*Sapphire Wind Farm - Modification No. 1*

**MP/09\_0093**

**Sapphire Wind Farm - Modification No. 1**

Figure 1: Approved Project Layouts with areas highlighted for wind turbine removal

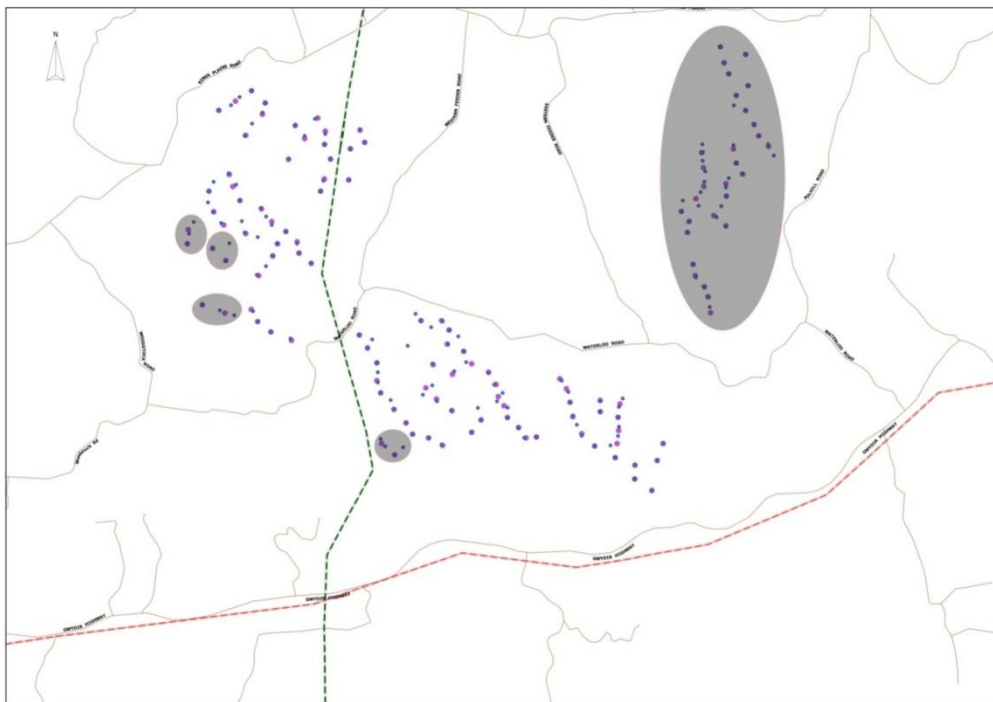
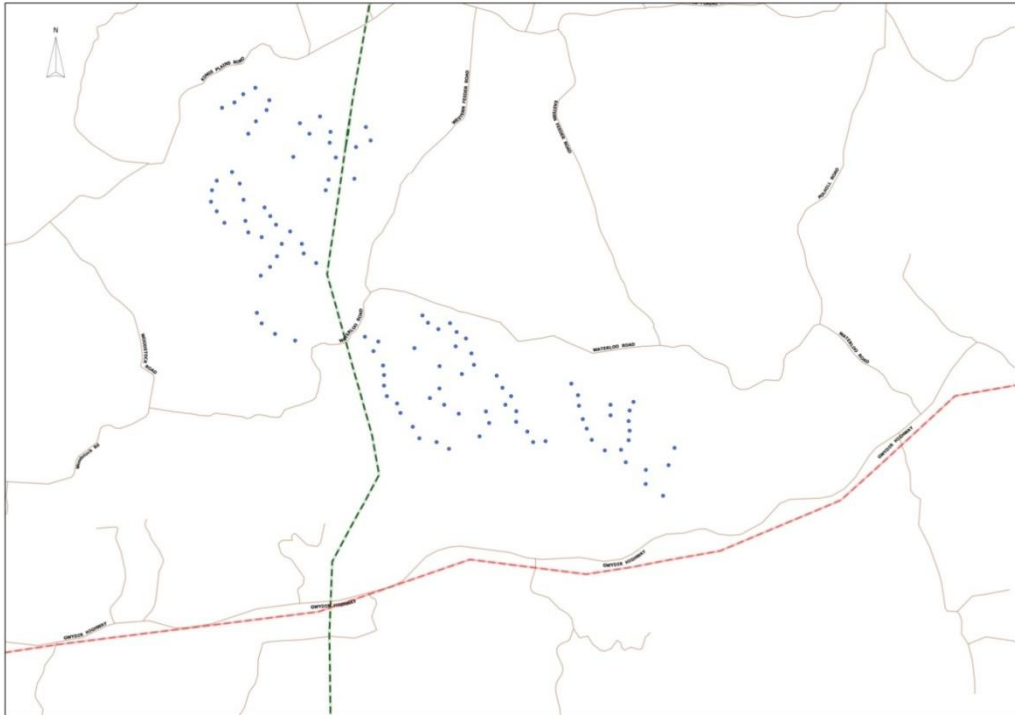
The modified Project will comprise of up to 109 wind turbine generator locations from the approved 159 wind turbine layout (previously referred to as Layout 1). This reduction is from five key areas of the Project, but most notably involves the removal of the Wellingrove cluster in its entirety (Figure 1).

Figure 8: Areas of Layout Micrositing (An A3 version is included in Appendix A)

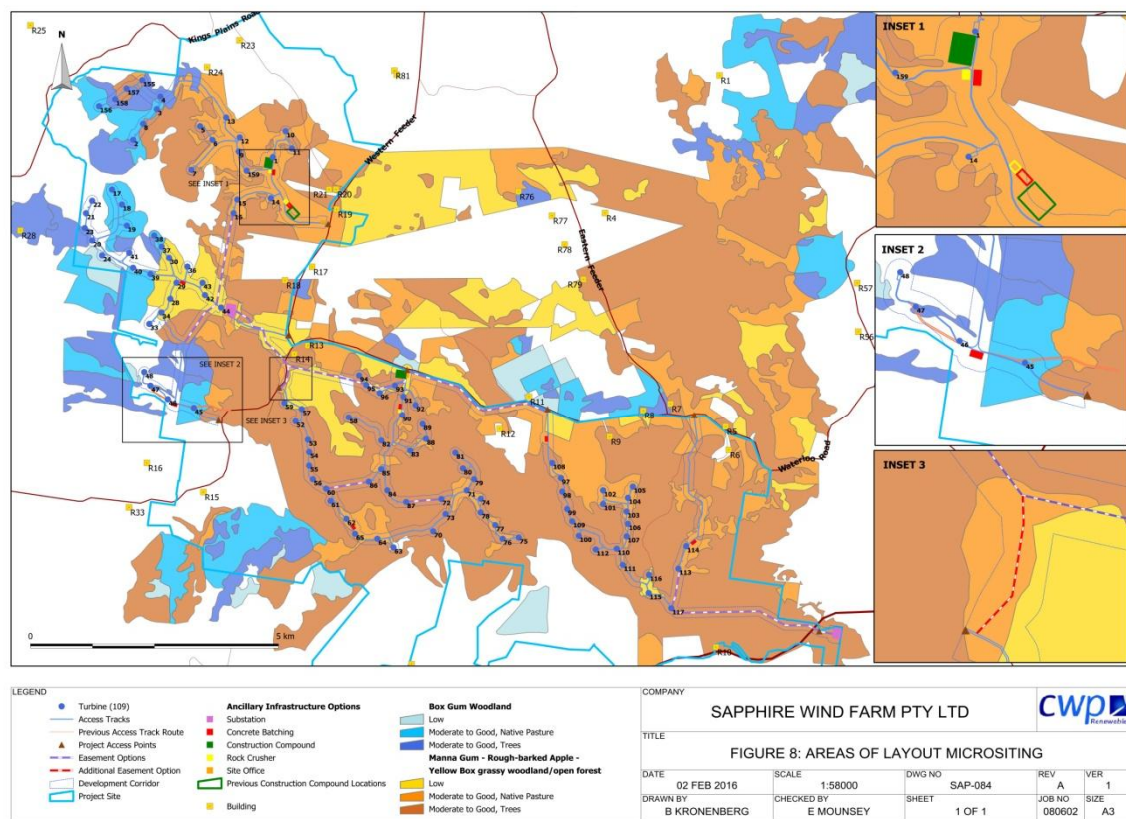
In addition to the wind turbine generator amendments detailed above, this modification also deals with some minor changes to the on ground road and electrical design. These changes are depicted in Figure 8 with the associated impacts considered in the ecology and heritage reports attached to this modification. (Note that these changes to the on ground road and electrical design have been included in Figures 3 to 7 above).
